NEW ORLEANS TO VENICE, LOUISIANA

EMPIRE FLOODGATE

PERIODIC INSPECTION REPORT NO. 8

CELMV-ET-EG (CELMN-ED-GE/23 Oct 96) (11-2-240a) 3d End
Mr. Bragg/bab/5893
SUBJECT: 1996 Periodic Inspection Report for No. 8 for Empire
Floodgate

PHOTO NO. 6 - BADLY DETERIORATED HANDRAILS ON THE BOAT DOCK.

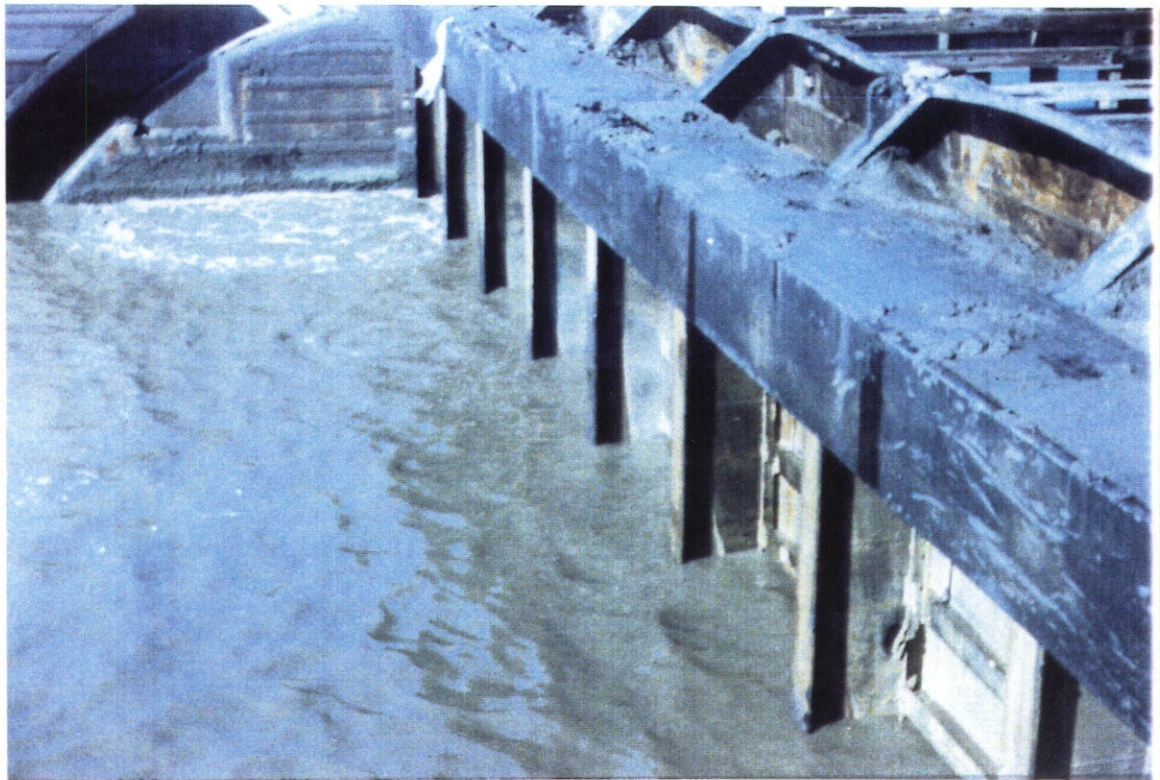
(3) The handrails on the boat dock have deteriorated to such extent that they no longer provide the safety features they were designed for. See Photo No. 6. The handrails on the boat dock should be repaired or replaced as applicable (depending on their condition) and properly reinstalled.

PHOTO NO. 27 - VIEW OF SHEET PILE FLOODWALL SHOWING
COMPLETELY DETERIORATED COAL TAR EPOXY.

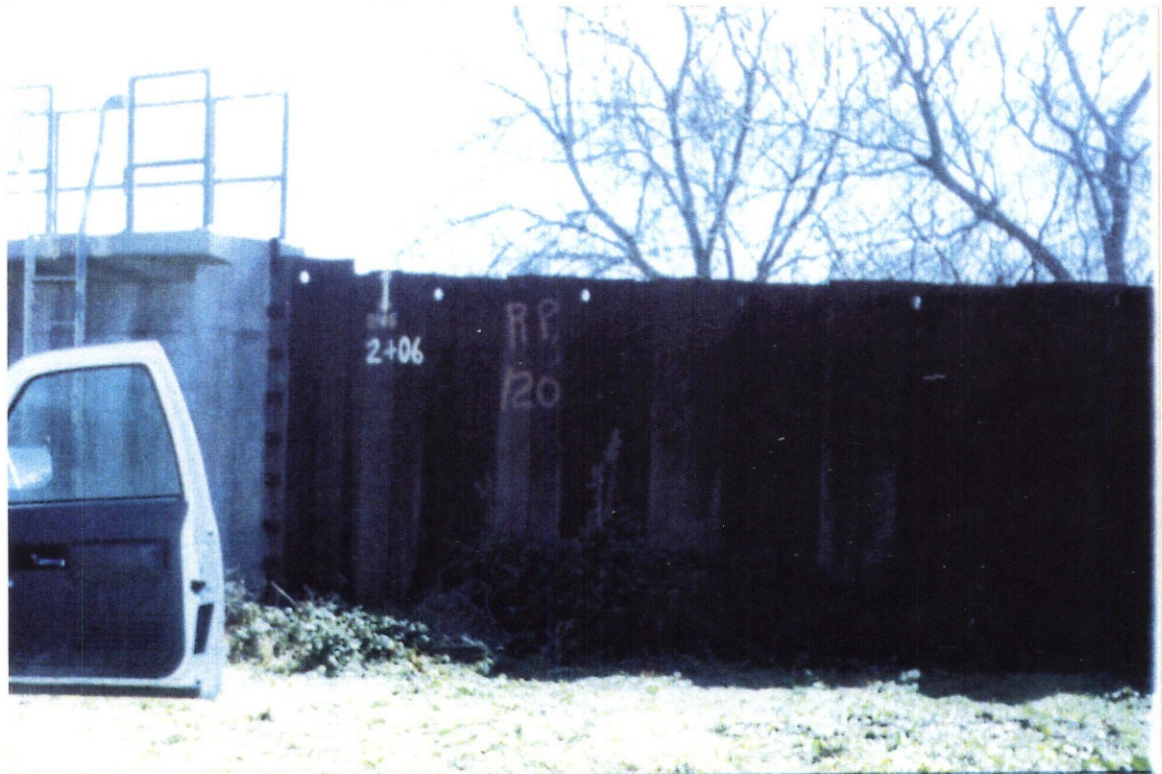
(2) The coal tar epoxy protective coating originally applied to the areas of sheet piling near the ground line has completely deteriorated. See Photo No. 27. It is recommended that the sheet piles be cleaned and painted with coal tar epoxy from slightly below ground line up to the tops.

walls, the sheet piles will be cleaned and painted with coal tar epoxy from slightly below the ground line up to the tops.

Photo #1 Concrete popout on concrete walkway and Gatebay.

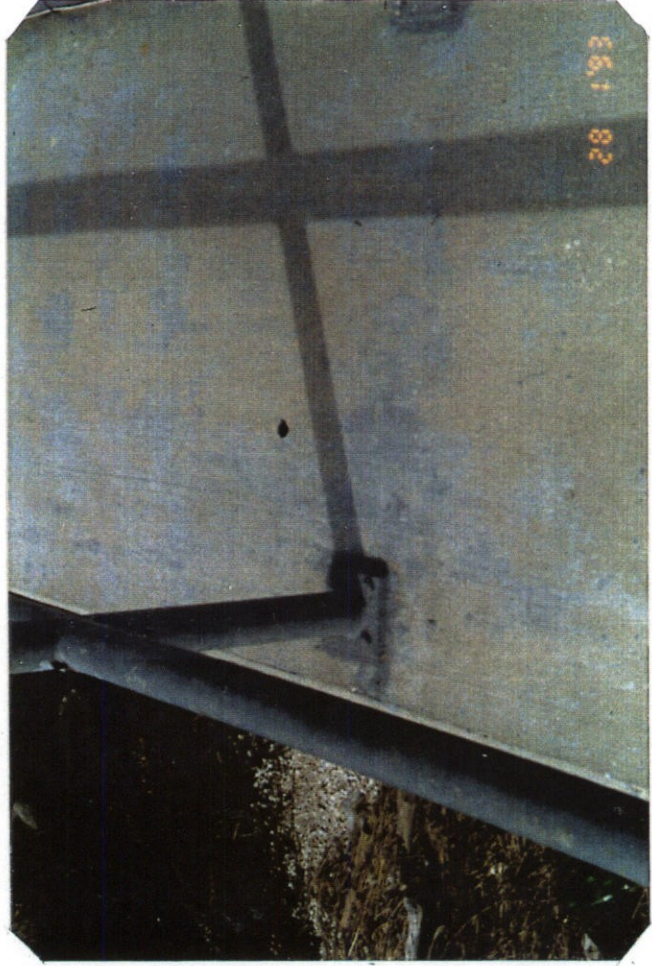
1. Floodwall. Overall, the floodwall was in very good condition, some concrete popouts were found on the surface of concrete walkway on top of inverted T-wall and gatebay. (See Photo #1). A gap of approximately two and a half to three inches was observed between the L-type waterstop that is attached to sheetpiling and the adjacent T-wall monolith on the west side of the structure. The L-type waterstop was not secured to the sheet pile on the floodside.

Photo #2 Protecting coating corroded and crumbled.

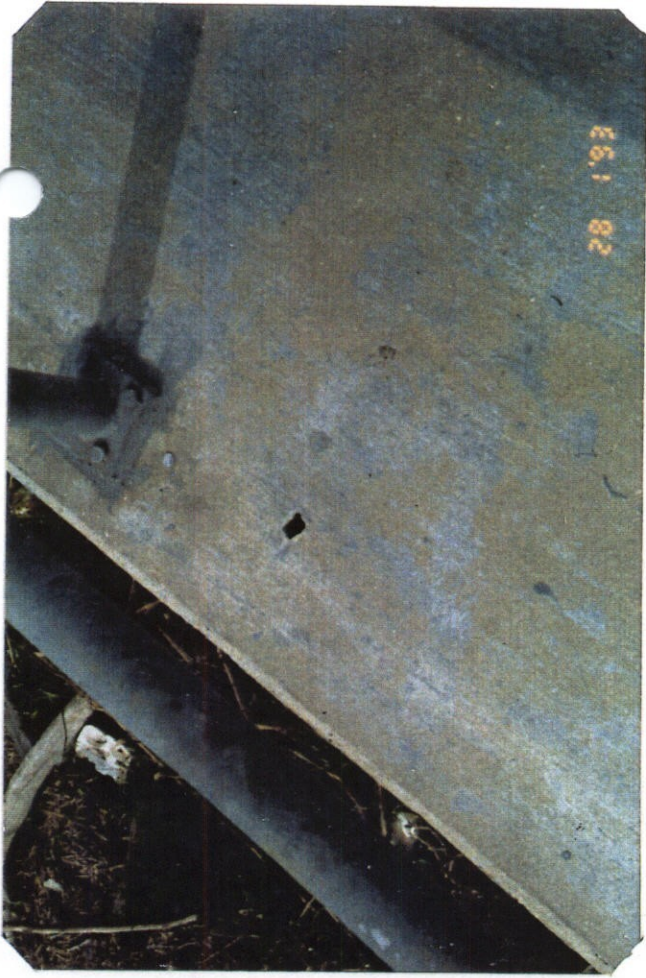
2. Steel Sheet Pile. Generally, the steel sheet pile was in good condition. Except, the protective coating along the bottom portion of the sheet pile above the ground were corroded and crumbled. (See Photo #2).
